**Failure Modes and Effects Analysis
(FMEA) of the ICS/NNI Electric Power
Distribution Circuitry at the
Oconee 1 Nuclear Plant**

A. F. McBride
C. W. Mayo
R. E. Battle

Manuscript Completed: August 1985
Date of Issue: October 1985

Fig. 3.9. Hand stations IRC4A, IRC4B, IRC5A, IRC5B, IRC4, IRC5, and IRC12.

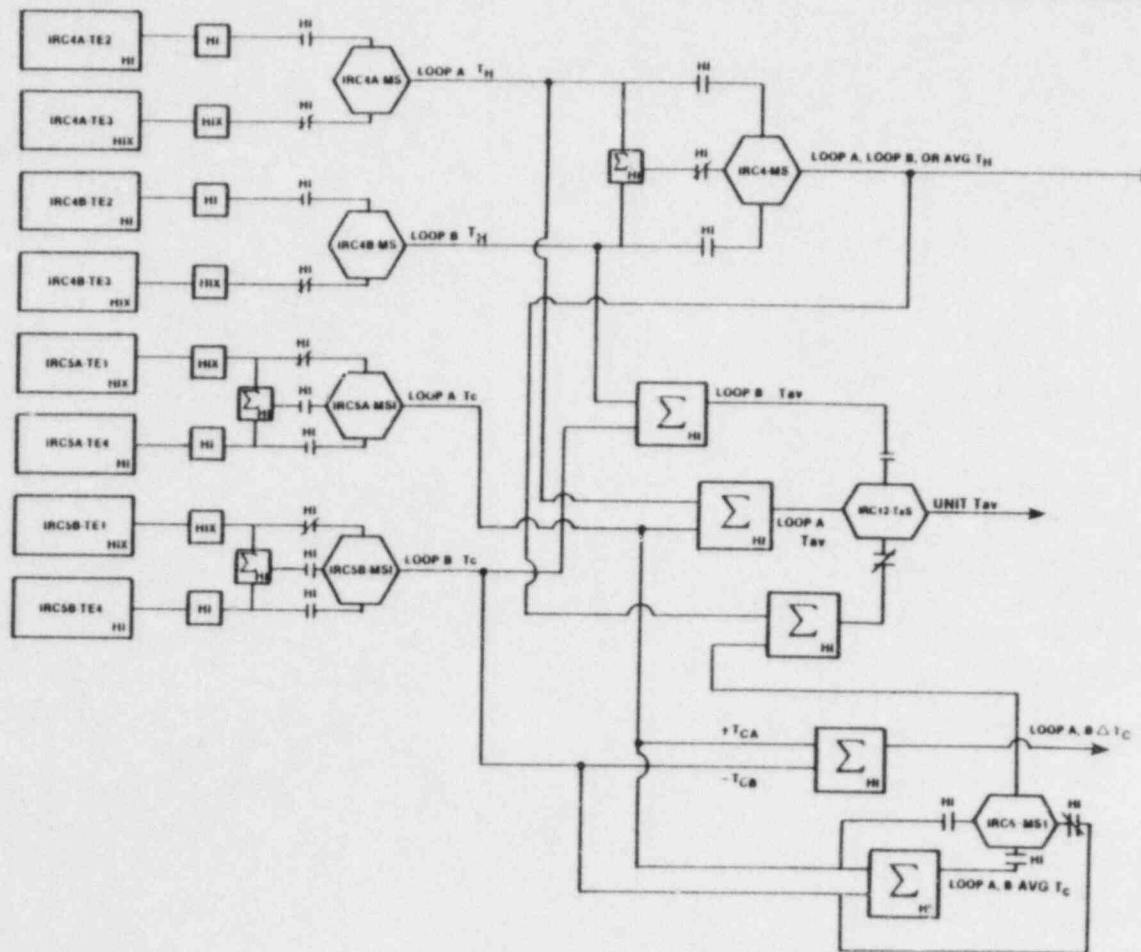
Comment 5: A key to the symbols in Figs. 3.1 through 3.9 would be helpful.
